FCC ID/IC ID Location for AW-AM510

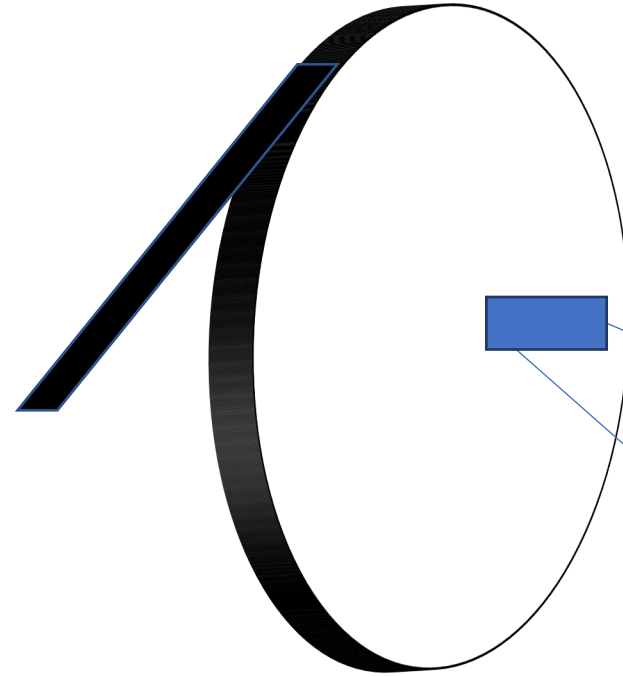
If we use a soldering machine with the label attached to the RF module,
Labels burn due to the high temperature inside this machine.
So, change the location of the label.
